Enclosure 2  
Meeting Summary Handouts  
of the January 19, 2012  
ROP Public Meeting

## Reactor Oversight Process Task Force FAQ Log

**Tentative NRC Response to  
FAQ 11-12, FitzPatrick Downpowers**

**FAQ 11-13 (Proposed)**  
**Suspension of Siren Testing for Weather Related Issues**

Diagram 1: Low flow area with debris build-up behind Boot

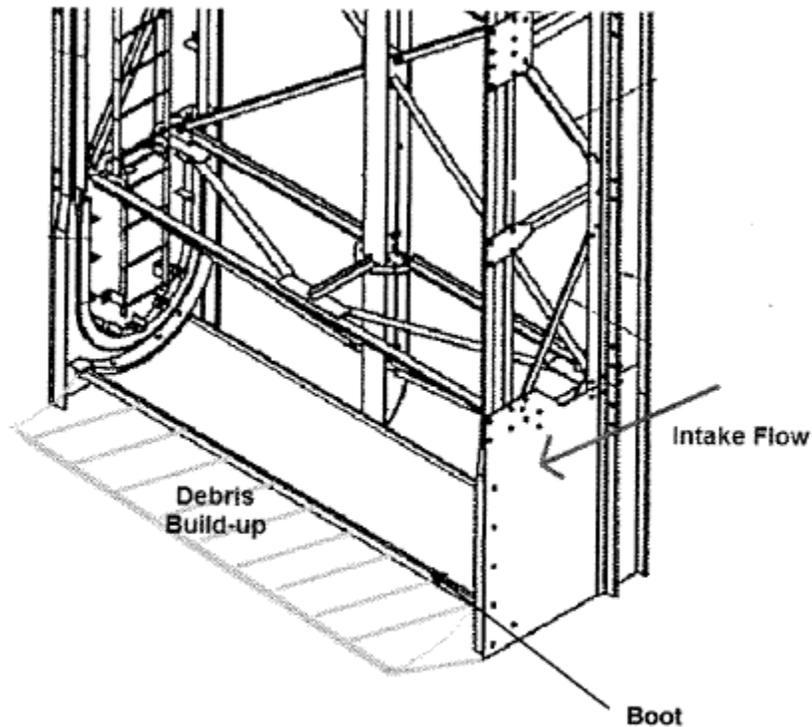
The travelling water screens have a cement filled boot below the screens that runs down to the intake bay (see Diagram 1 below). Due to this design, the annual PM now includes a boot inspection. It was to support this inspection that the gates were inserted.

Based on the need to downpower the unit JAF performed an apparent cause evaluation and determined that the fouling observed was from a previously unidentified source. Based on the design of the boot and the cement, it appears that a low flow area may be forming just past the

boot. There is a possibility for small debris such as silt, sand, and broken zebra mussel shells to settle in this area south of the screens (pump suction side). In this area, the silt may settle out past the boots and build up to a level to meet up with the process flow. This condition would only take a short period of time to build-up and then would remain in the condition until cleaning could remove the debris.

During normal operation, this debris build-up is not a significant threat to fouling because the debris is settled. However, this area becomes vulnerable when the gates are installed because of the change in flow patterns and increased velocity.

During the maintenance activities beginning on 6/6/2011, the south gate was inserted to provide protection for the divers. The installation of the gate caused an increase in flow, which apparently caused the settled debris in the vicinity of the gate to be picked up by localized turbulence, resulting in fouling of the condenser. The apparent cause evaluation postulated

Although the licensee may have been aware that condenser fouling during the maintenance or inspection activity could potentially cause a downpower, the licensee was not planning to downpower to conduct the maintenance/inspection. The licensee stated in the FAQ that it could not reasonably anticipate that the debris south of the travelling water screens would have been sufficient to cause the observed condenser fouling. This statement indicates that the licensee was not planning to downpower. Therefore, the staff considers the downpowers to be unplanned.

NEI 99-02 has guidance for allowing contingency downpowers under certain conditions (page 14, lines 6-8) and anticipatory downpowers in response to certain external events (page 14, lines 38-40) and environmental events (page 14, lines 42-47, and page 15, lines 1 – 29). The external and environmental event guidance reflects situations that are not caused by the licensee and for which the licensee cannot predict or control the timing. Although marine debris is environmental matter, the licensee's action of closing the gates created new flow patterns that transported the debris into the condenser, which has happened at this site in the past. NRC staff does not consider this situation to qualify for the contingency or external or environmental event exclusions in NEI 99-02.

NEI 99-02 also states that the licensee is expected to take reasonable steps to prevent intrusion of animals, marine debris or other biological growth from causing power reductions. Although the licensee cleaned the intake structure area prior to the maintenance, the NRC resident inspector identified licensee condition reports that indicated that several inches of debris were south of the traveling screens some time after installation of the new screens. Based on similar occurrences of this amount of debris causing condenser fouling in the past, the staff believes the condenser fouling could reasonably have been anticipated.

NEI 99-02 states that intrusion events that can be anticipated as a part of a maintenance activity would normally be counted. The staff believes these events could have been anticipated and that the exclusions provided in NEI 99-02 were not applicable. The staff's decision is that the downpowers should have been counted in the PI.
